**Badger Coulee 345 kV Transmission Line Project**  
**Construction and Mitigation Plan (CMP)**  
**Segment 1**

## **CMP Amendment 1 – Minor Route Adjustment 1 (Segment 1)**

### **Badger Coulee 345 kV Transmission Line Project**

**Badger Coulee  
Temporary Clear Span Bridge Typical Drawing**

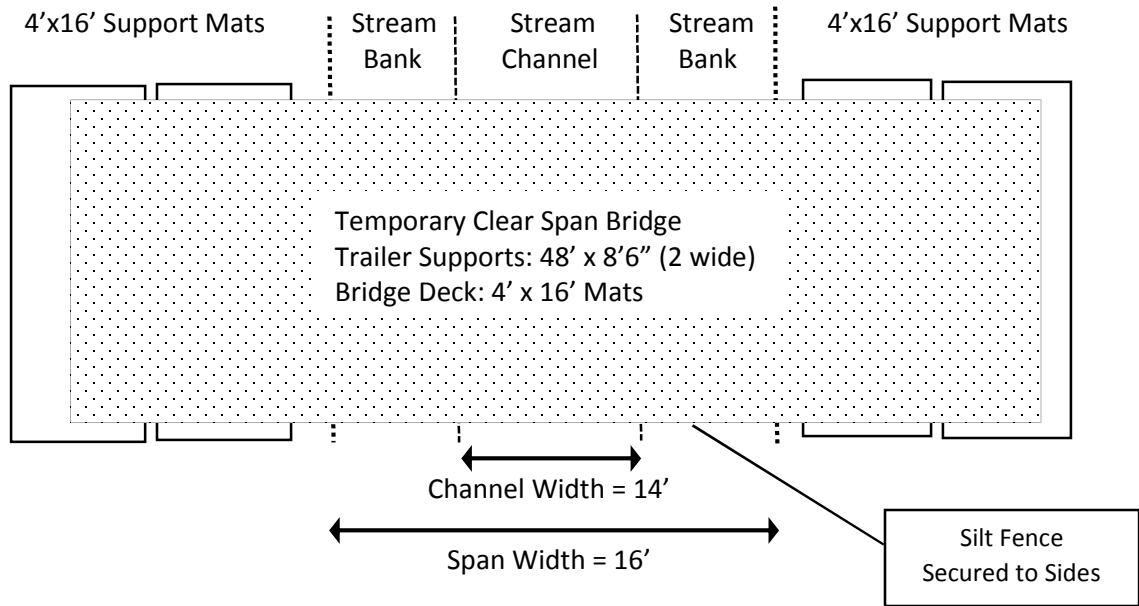
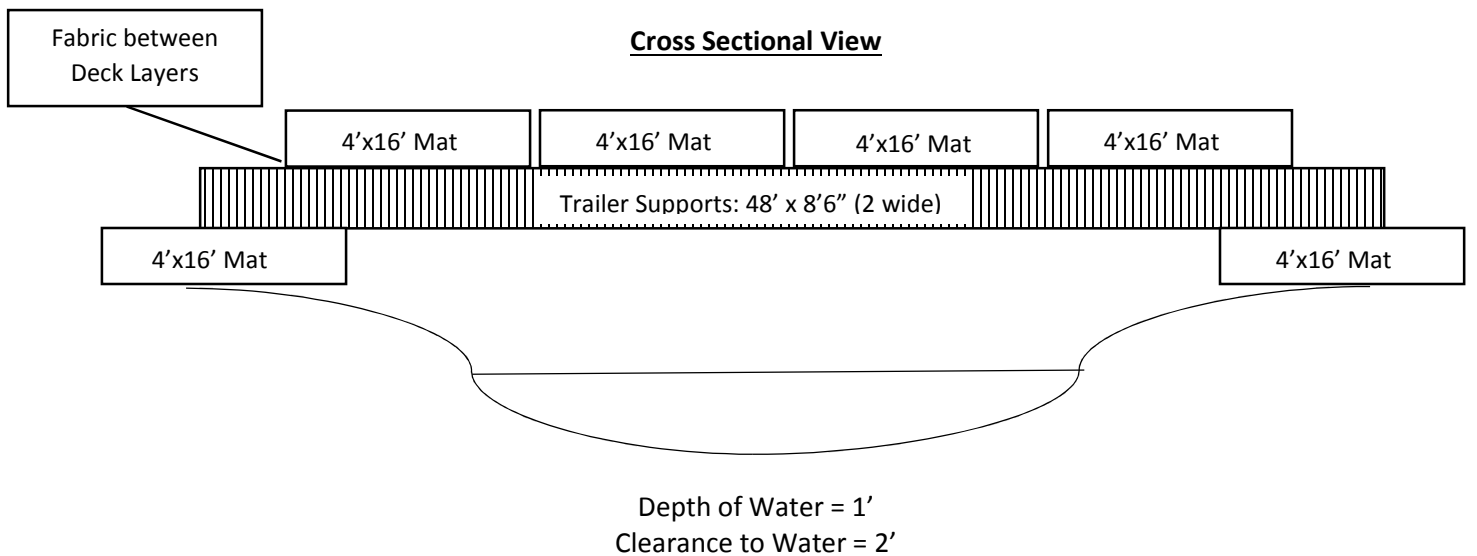
Construction will require access through wetland A-W3 along the new ROW alignment and from off-ROW to the west. This access route will also require a TCSB crossing at waterway A-R1. This access route differs from the original alignment in the CMP in that no access is required through wetland A-W2 and a TCSB crossing is not needed at A-R1a. Additionally construction of the MRA alignment will not require wire setup areas within wetland A-W2.

As discussed above, one TCSB crossing at A-W1 will be required for the MRA. Final plan and cross-sectional view of the TCSB crossing is attached. General Condition #51 of the utility permit indicates the TCSBs should incorporate measures to minimize soil reaching the waterways. As shown on the plan, silt fence will be attached to the bridge sides and fabric laid between the deck layers or to accomplish this purpose, or a similar protection measure will be implemented.
